Staff Report

To: Salt Lake City Planning Commission
From: Casey Stewart; 801-535-6260
Date: April 5, 2018 (For April 11 hearing date)
Re: PLNSUB2017-01071 361 Reed Avenue Planned Development

PLANNED DEVELOPMENT

PROPERTY ADDRESS: 361 W. Reed Avenue
PARCEL ID: 08-25-378-003
MASTER PLAN: Capitol Hill Master Plan
ZONING DISTRICT: MU (Mixed Use)

PROPOSED SITE PLAN

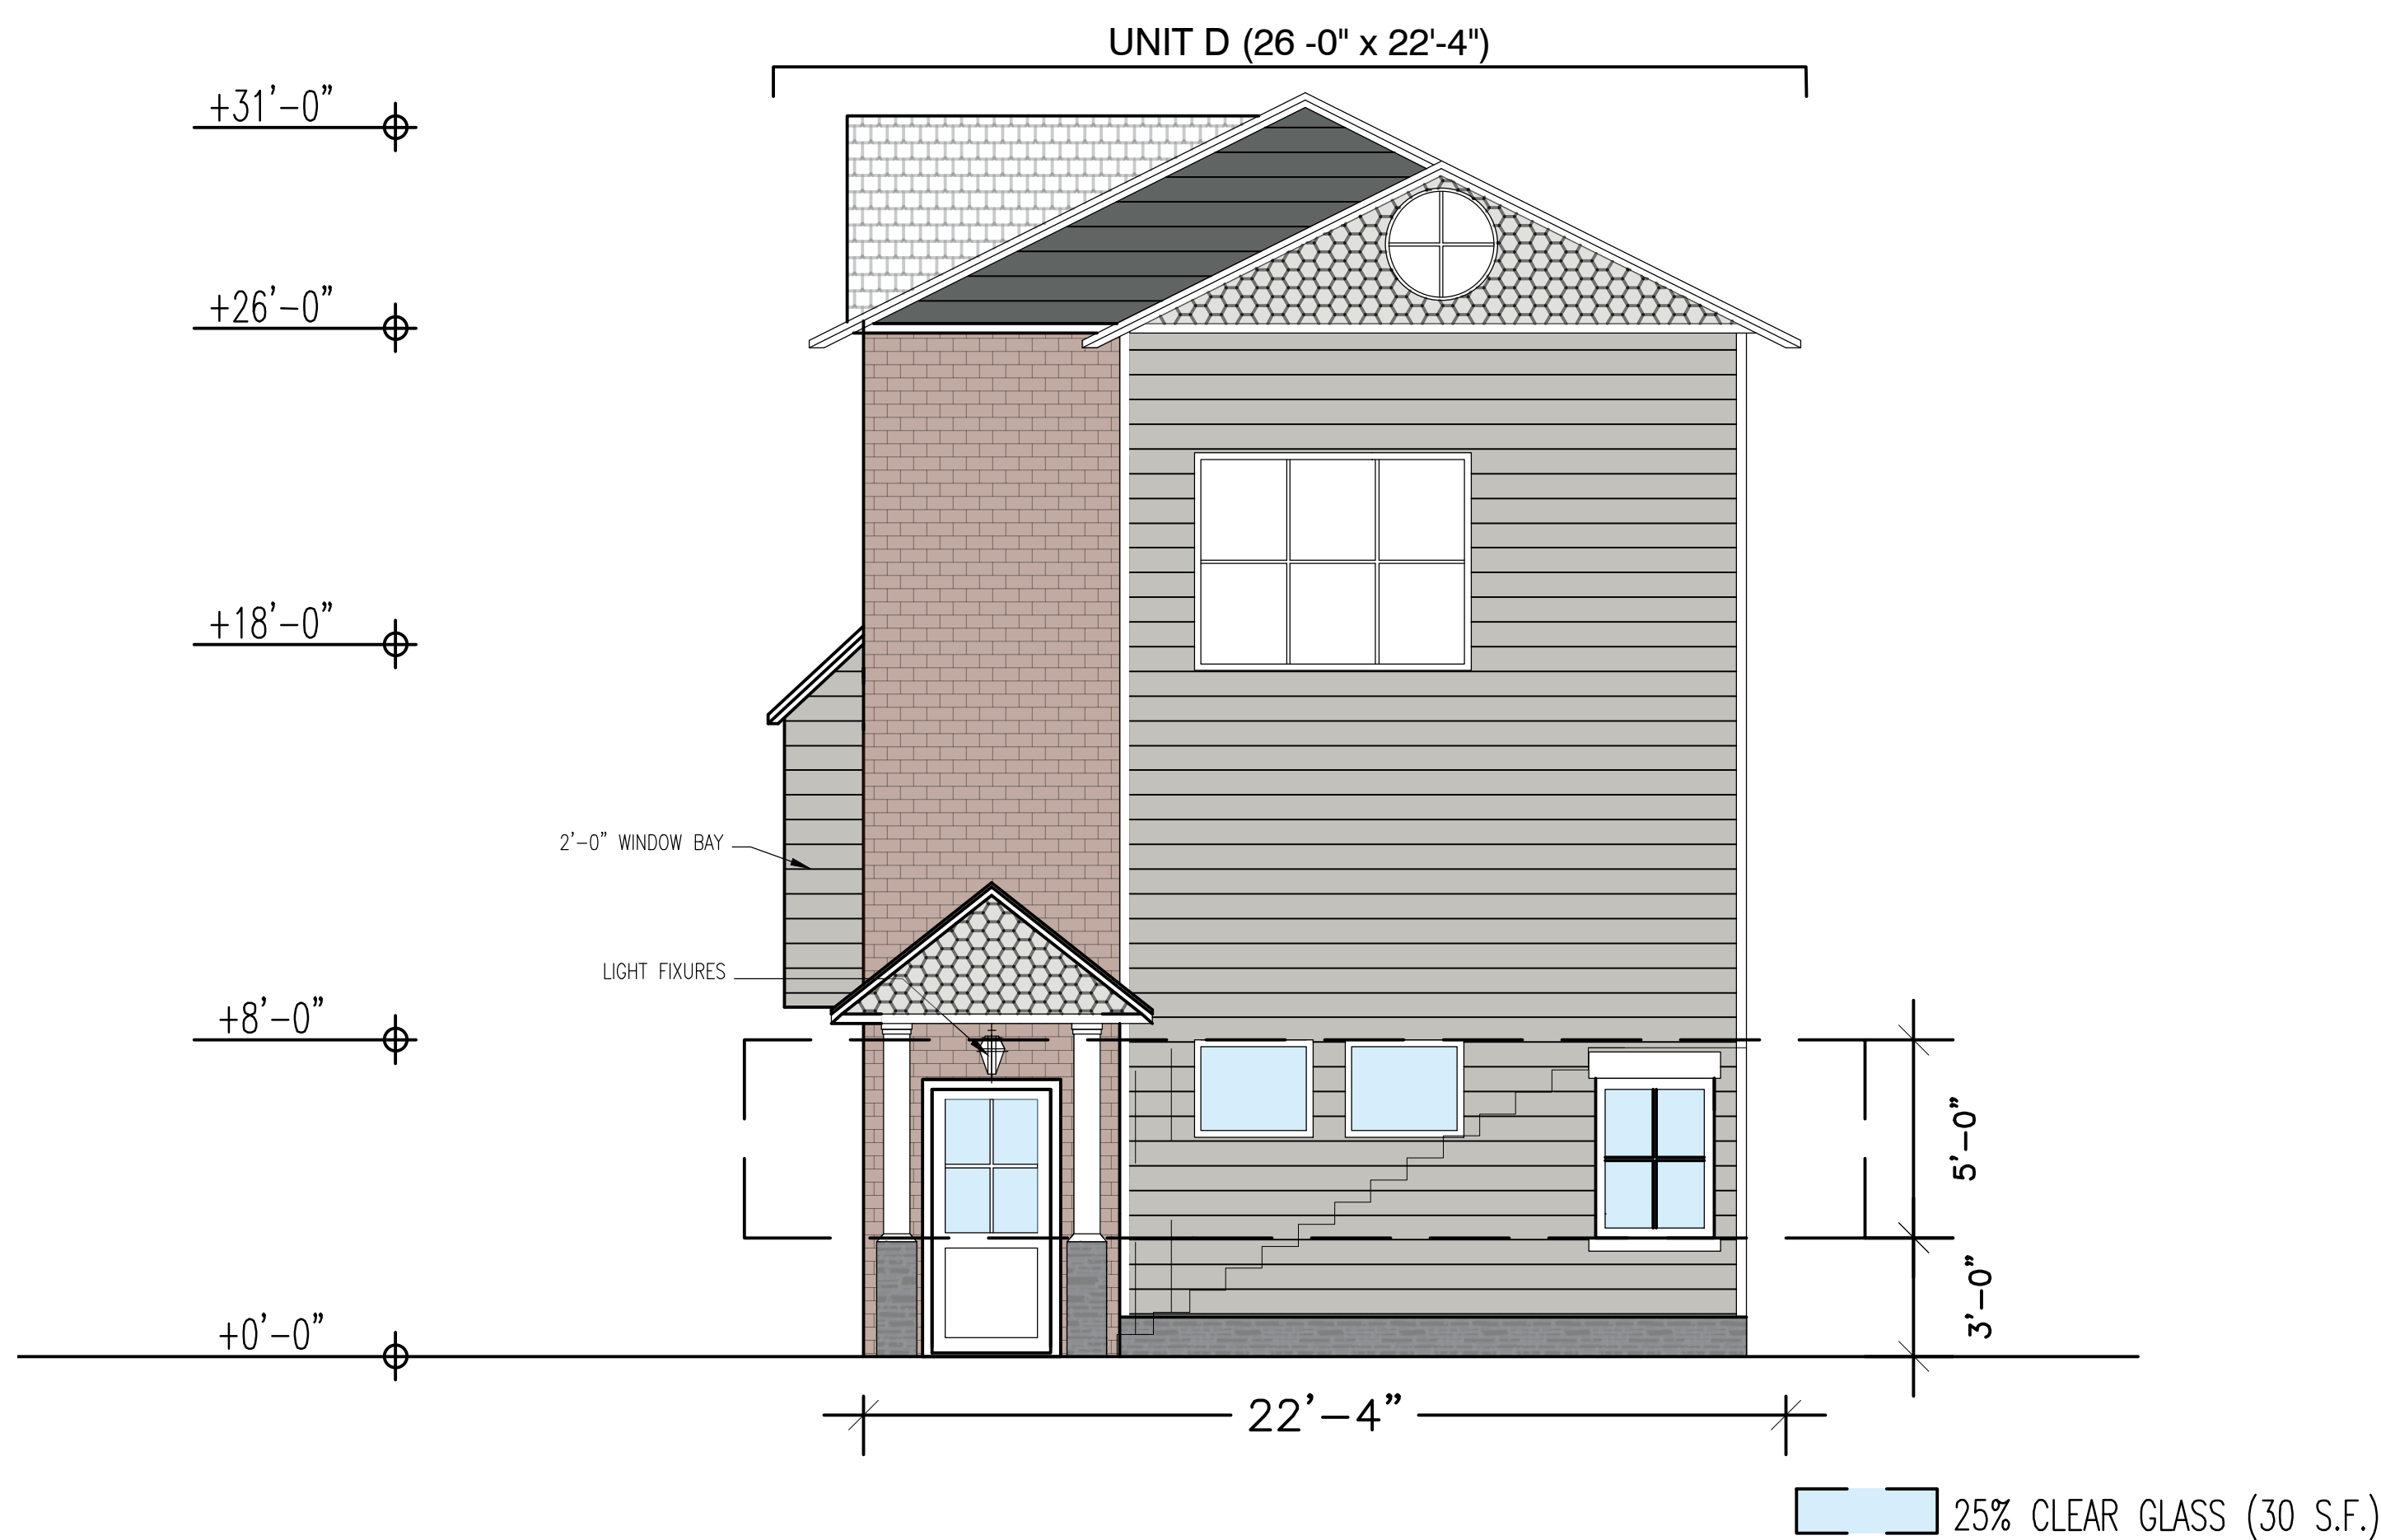
The applicant requests approval for a reduction of side yard setback requirements from 10 feet on both sides down to 7 feet. These reductions would allow for the proposed residential four unit condominium building. The existing lot is 37 feet wide, which is narrow for any project, particularly a multi-family project. If the standard side setbacks were applied, that would result in a building that is 17 feet wide and would offer very limited floor space. The reduction would facilitate a 23-foot wide building and still allow for some side yard areas. The primary reason for the requested reduction is to allow dwelling configurations that are more typical of residential condominium units, resulting in a more usable and marketable product.

A primary issue with this lot is the vehicle access. Parking is proposed on site as required, via individual attached garages, but access to the garages would be from an adjacent private alley to the west and south. The applicant proposes to pave the alley for that section of the alley that is directly west of the property, leaving the south section untouched. The paved area would extend into the subject property and serve as driveways for the attached garages. The alley is legally only 16.5 feet wide, but portions of the properties on either side of the alley will be paved to make it function as a wider area and improve vehicle circulation, but it is unclear how the alley would be signed for vehicle circulation.

For multi-family uses, this provision prohibits a parking design that would require a vehicle to back into the alley to use a parking space. The intent of the parking code restriction is to reduce the number of vehicles using the alley for parking and thus reduce the potential for collisions in an alley. Multi-family uses generally have more parking than a single-family use and thus an increased potential for collisions. Additionally, when the restriction was written most alleys were unimproved and unpaved. Unpaved, dirt alleys would generally not hold up well with a high level of vehicle use.

The final alley issue is that the project leaves unanswered the question of who owns and controls the alley, granting permission to pave and otherwise modify, and how the alley and improvements will be maintained in the future. Since the alley is not expressly public, nor owned by the city, the city has no obligation to maintain the alley and the applicant has not provided a method for maintenance at this time but is not required by city ordinance to do so. It is up to the planning commission to determine how crucial the alley issue is to the overall planned development.

C.5. Buffering. The submitted documents show no buffering between the development and the adjacent house to the east. This is especially important because the developer is seeking to reduce the width of that side yard.

Alley access: Dimensions for parking space requirements are provided in Table 21A.44.020. The requirements for using the alley as an access are that there is a minimum of twenty two feet seven inches (22' 7") from the garage door to the opposite side of the alley for 90 degree, a stall length of seventeen feet six inches (17' 6") and a width of nine feet (9'). It doesn't look like there is enough room on the plan. That said, the garage door appears to be for a two-car garage (16'-18') and that would provide greater maneuverability (basically an extra, extra wide stall) and the designer could play around with the parking angle (i.e., 70 degree angle) and may be able to get it to satisfy the requirements per Table 21A.44.020. If the intent is to park two cars, then they need to revise the plans. *[Based on the dimensions, including the garage depth, driveway depth, and alley, the project complies with the alley maneuvering requirements.]*

-Will enough room be provided for dumpsters, garbage cans and/or recycle bins?

However, in this case, the alley would be paved, as proposed by the applicant, and does not have the same potential for vehicle use issues. Further, the proposed parking configuration functions the same as if the residential units were townhomes (single-family attached). The Transportation division also has determined that this is an acceptable configuration and would not pose any safety issues.
